# Railyards Specific Plan Update, KP Medical Center, MLS Stadium, & Stormwater Outfall

Final Subsequent Environmental Impact Report

P15-040 | SCH No. 2006032058

October 2016

**Figure 2-32**  
Stadium Field Level Plan

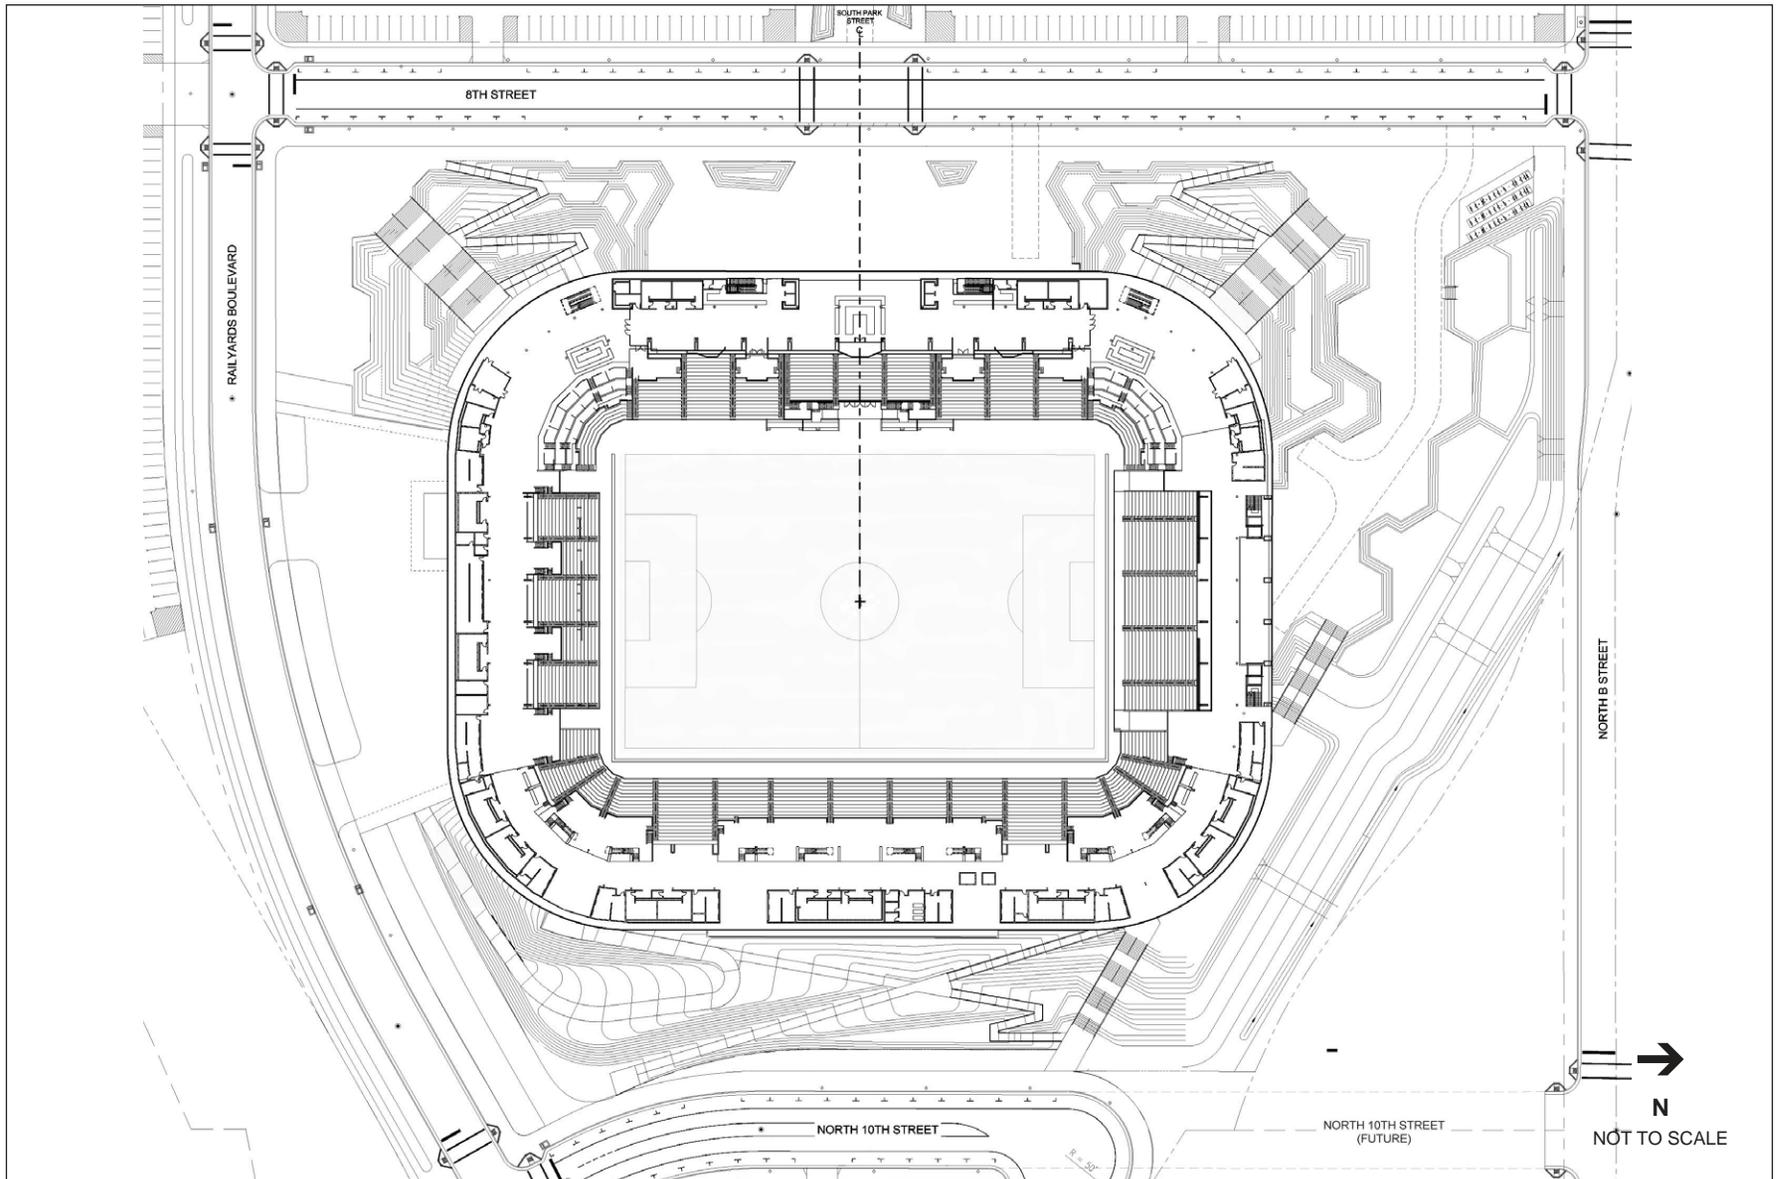
Figure 2-32, Stadium Field Level Plan, is revised to show the revised MLS Stadium location moved approximately 40 feet to the north.

**Figure 2-33**  
Stadium Main Concourse Level Plan

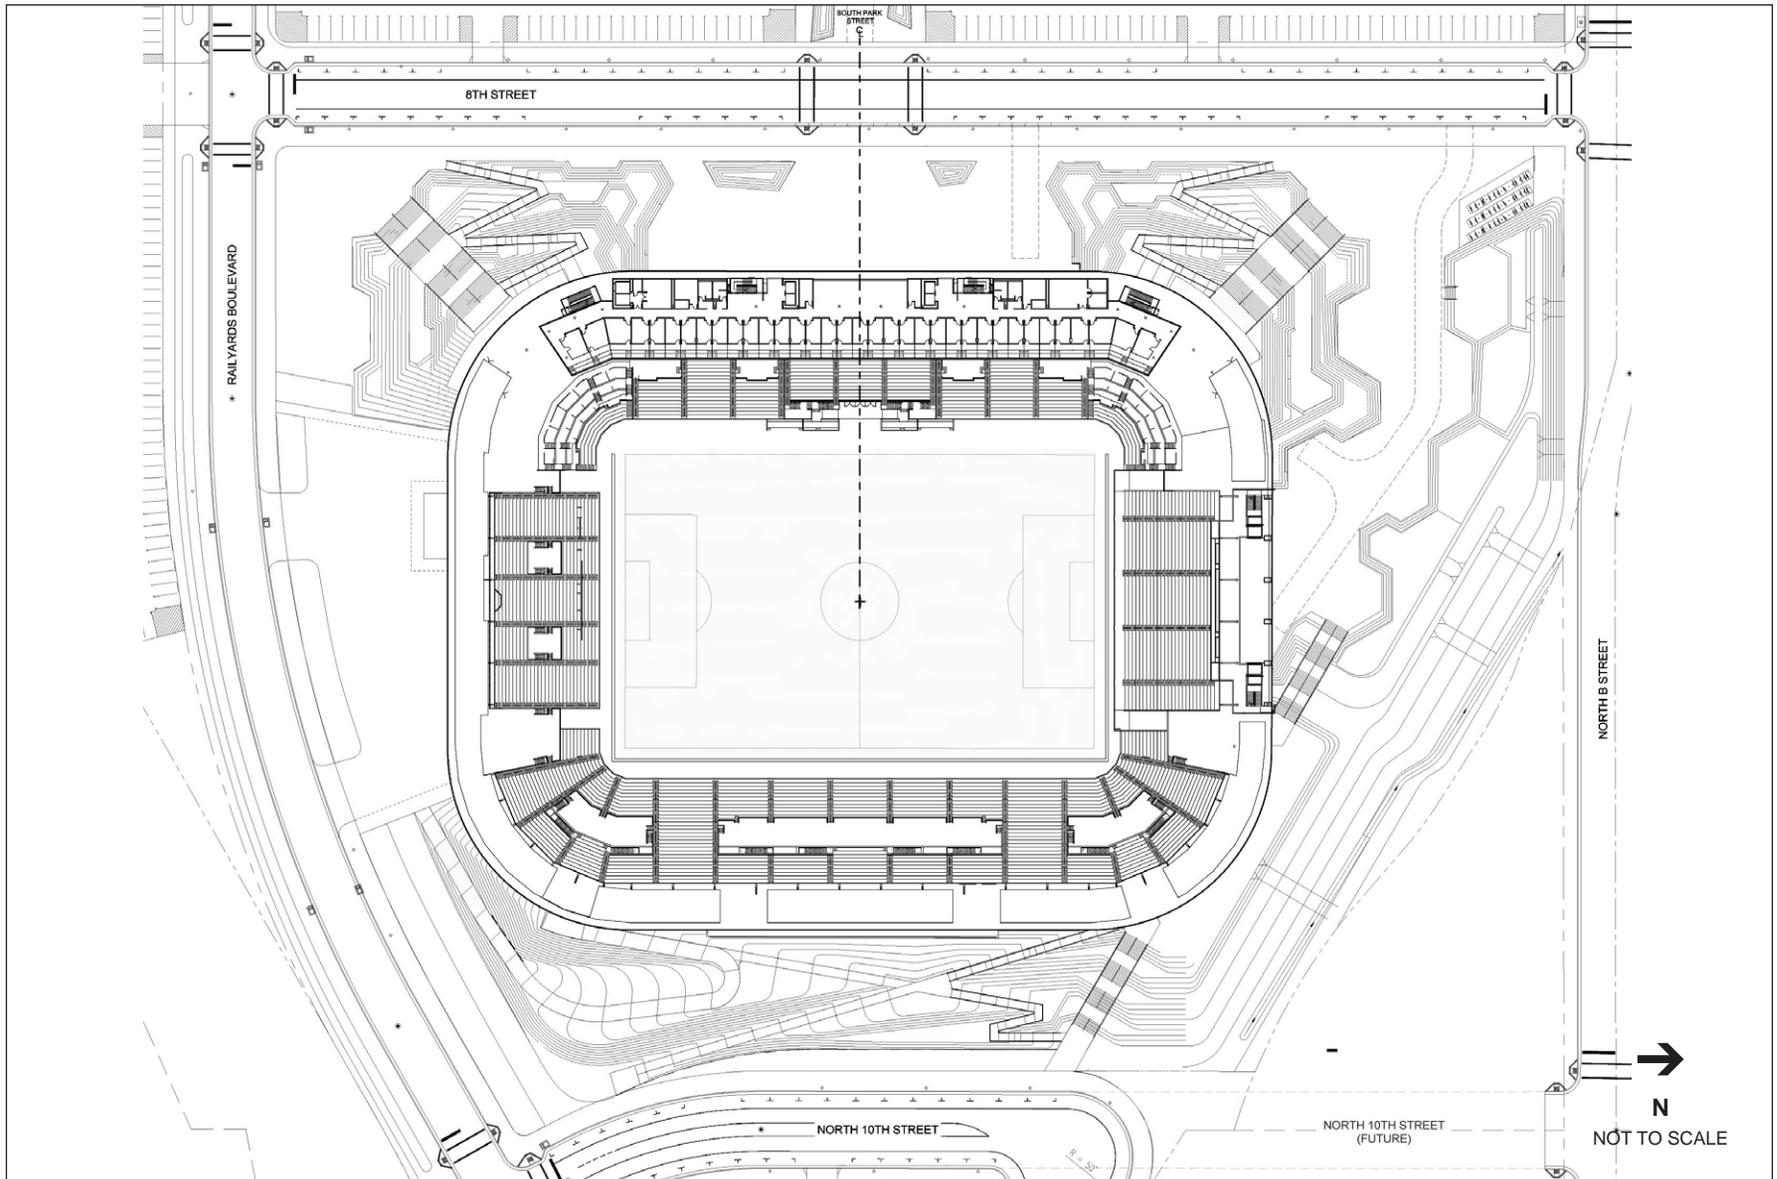
Figure 2-33, Stadium Main Concourse Level Plan, is revised to show the revised MLS Stadium location moved approximately 40 feet to the north.

**Figure 2-34**  
Stadium Suite Level Plan

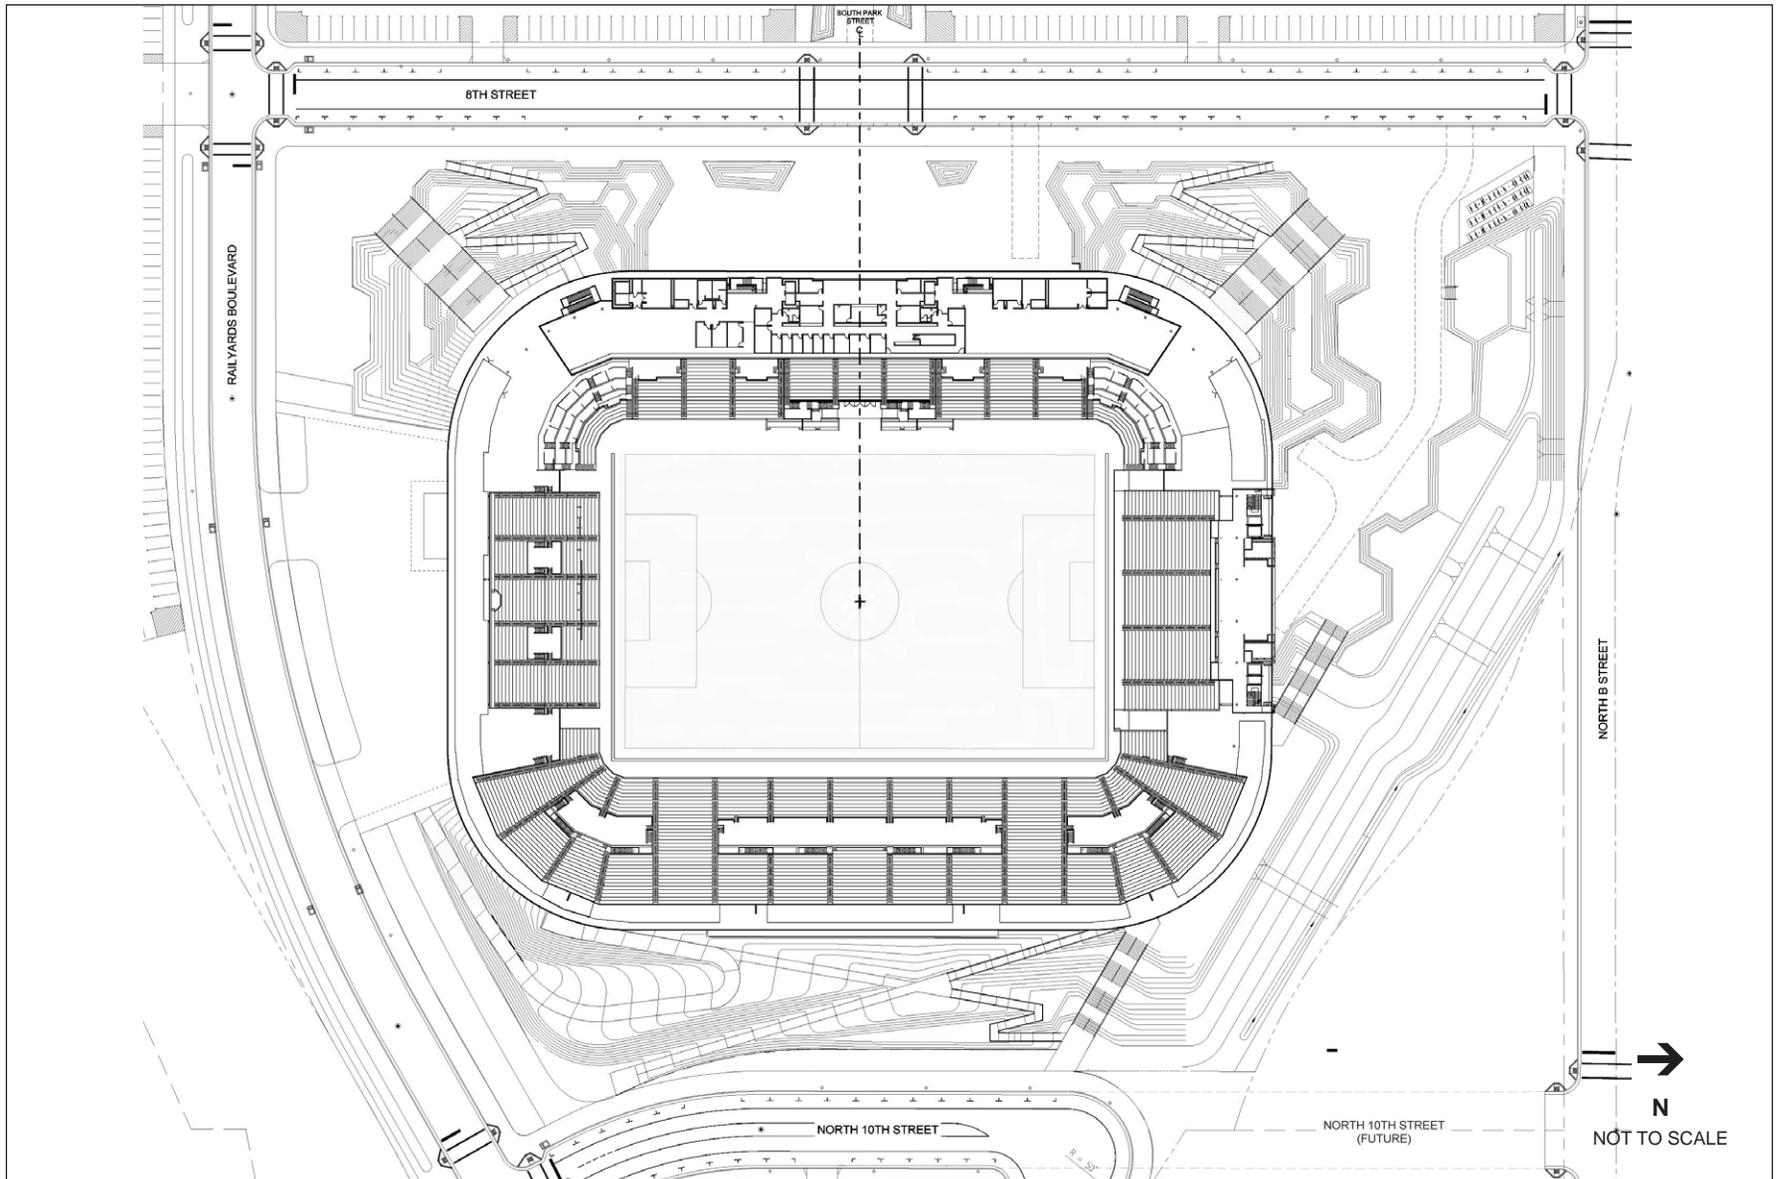
Figure 2-34, Stadium Suite Level Plan, is revised to show the revised MLS Stadium location moved approximately 40 feet to the north.

**Figure 2-35**  
Stadium Press Level Plan

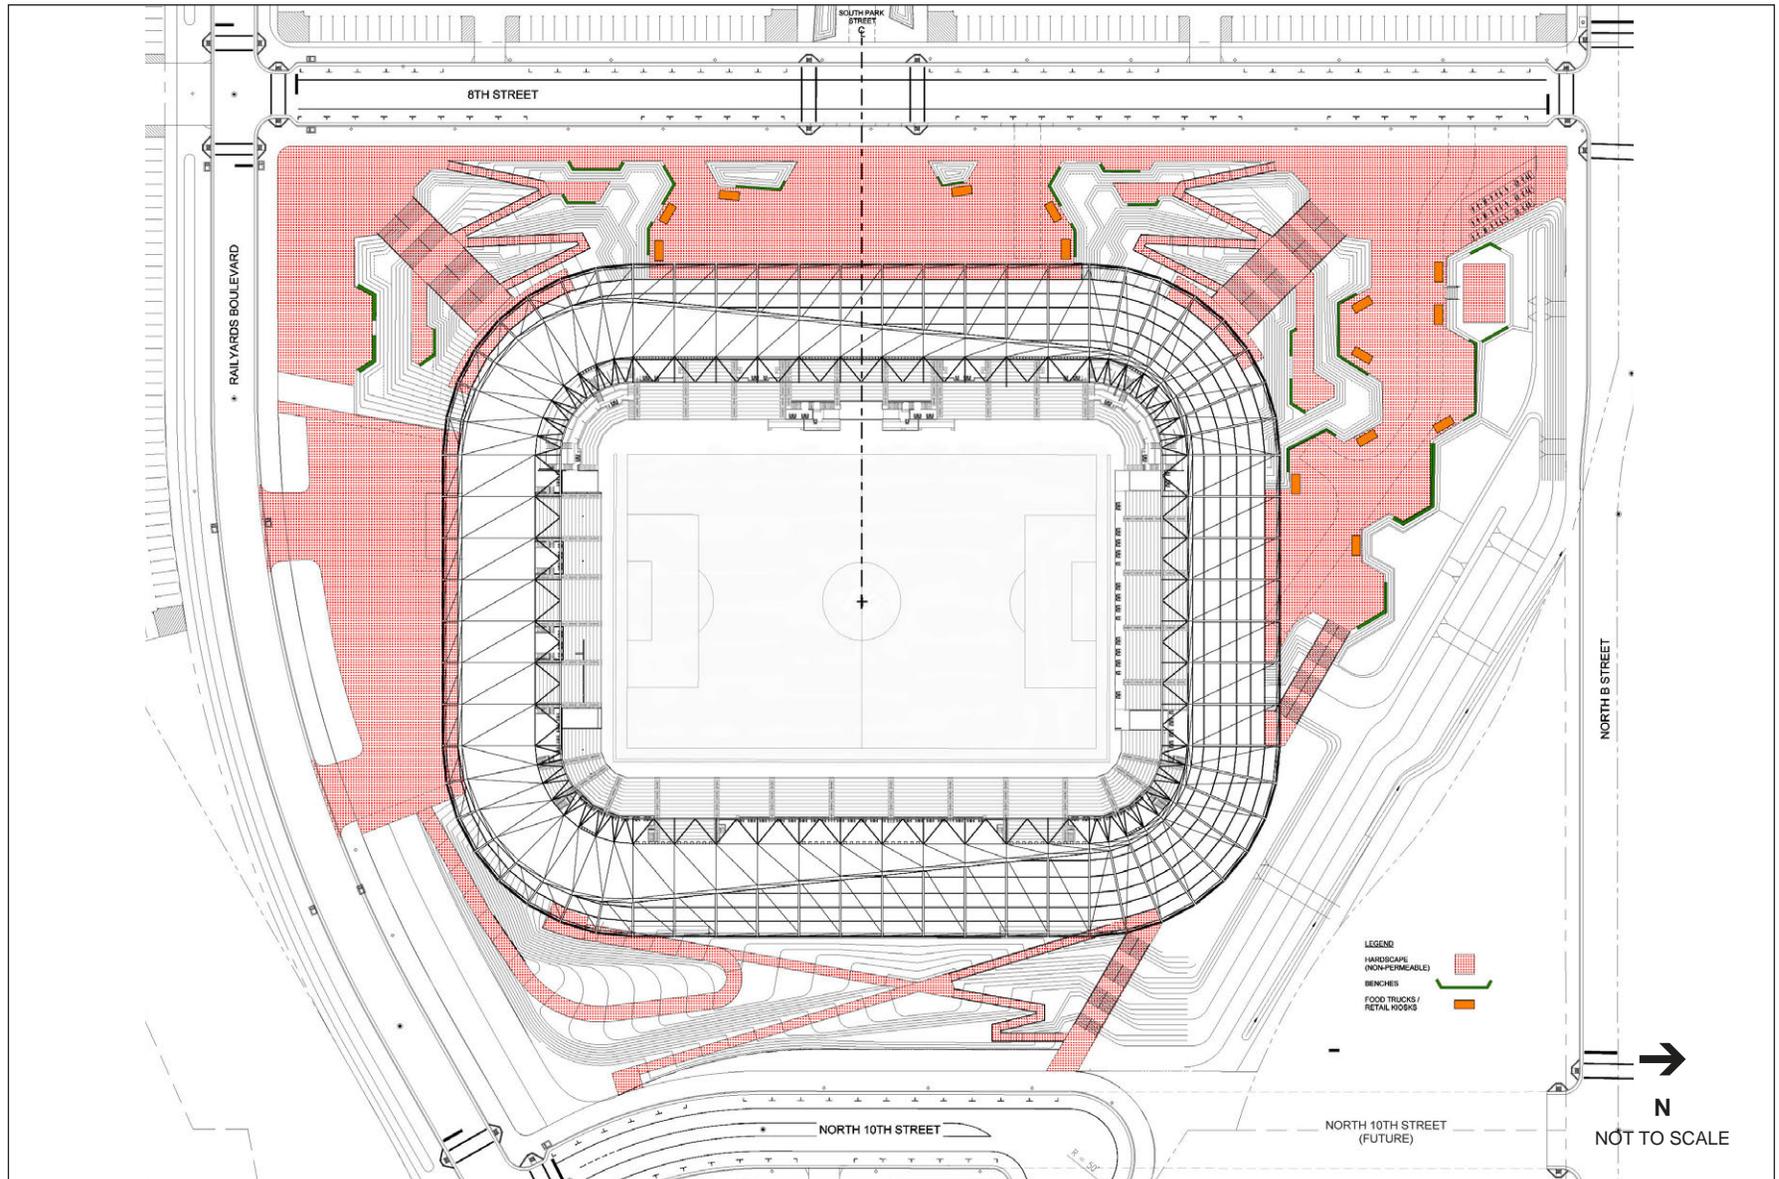
Figure 2-35, Stadium Press Level Plan, is revised to show the revised MLS Stadium location moved approximately 40 feet to the north.

**Figure 2-36**  
Stadium Plaza Plan

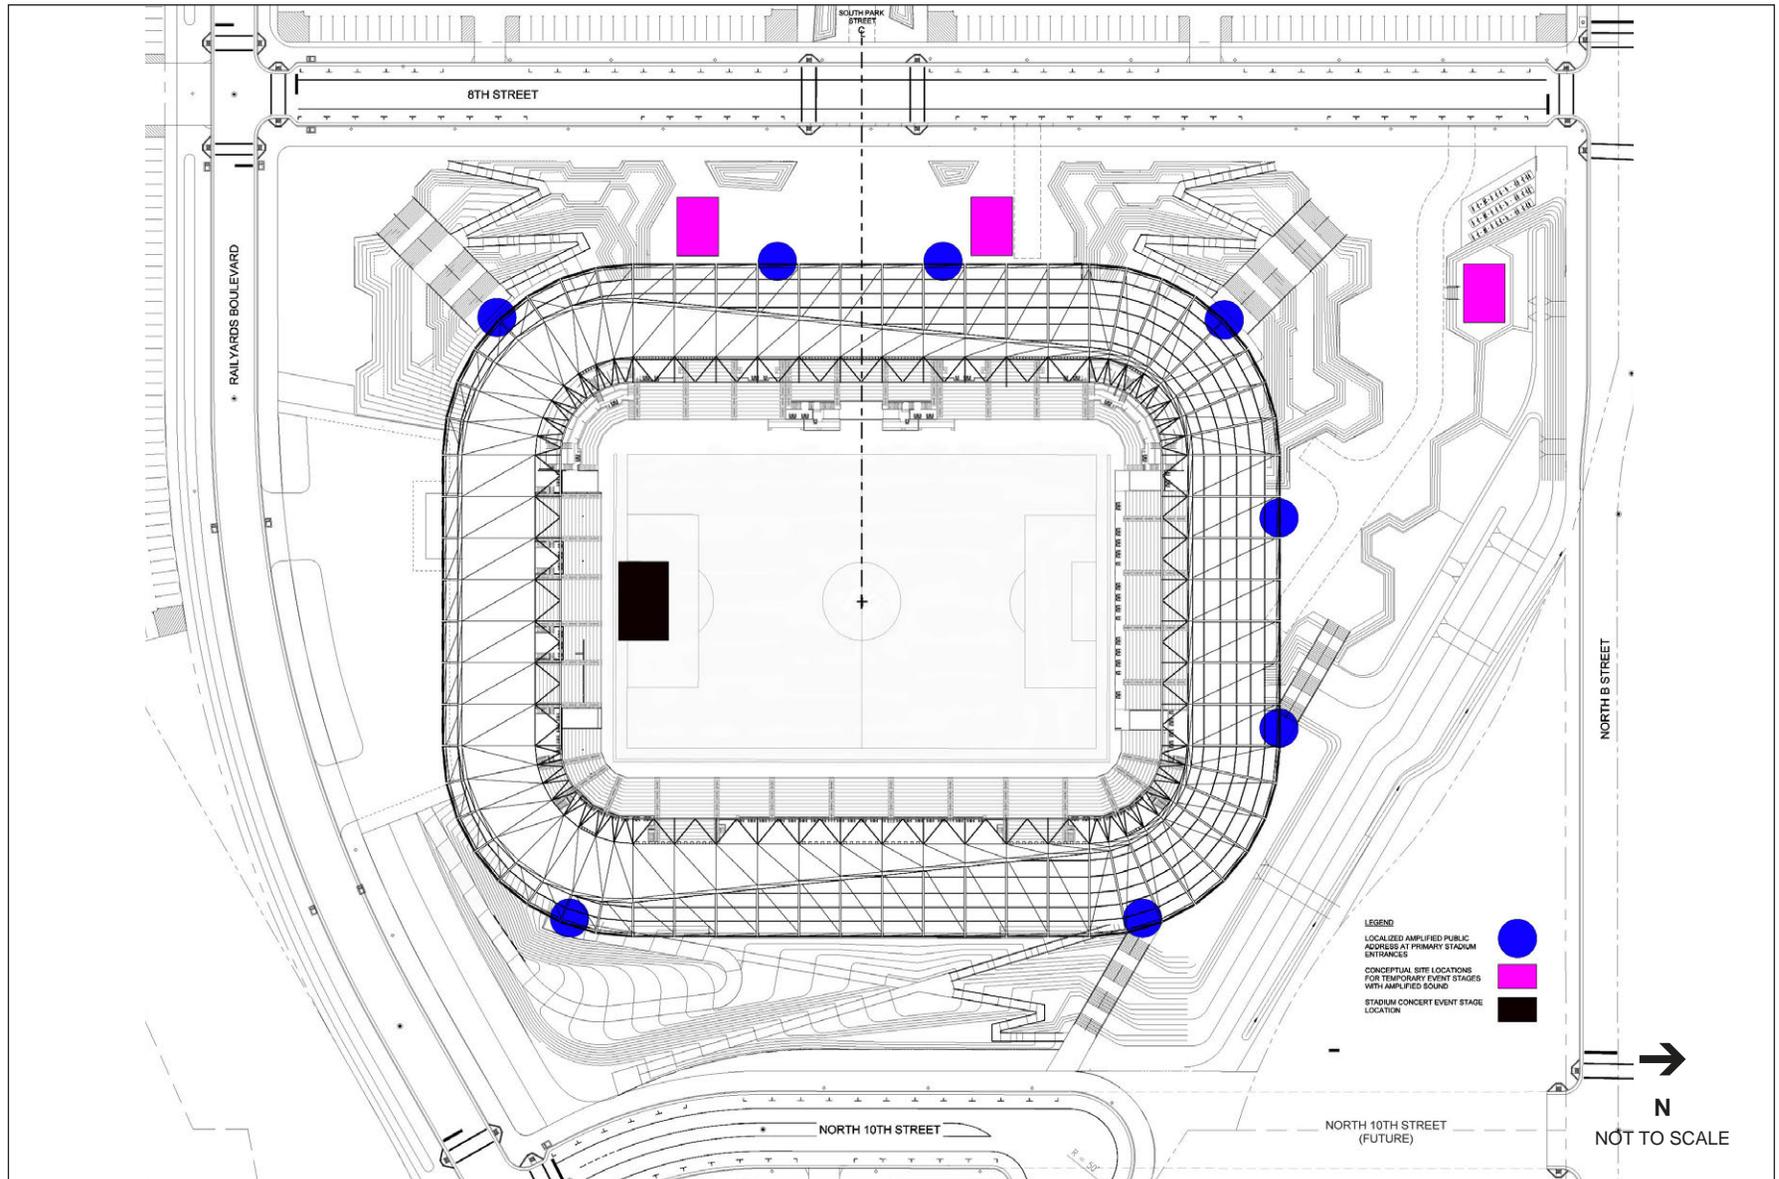
Figure 2-36, Stadium Plaza Plan, is revised to show the revised MLS Stadium location moved approximately 40 feet to the north.
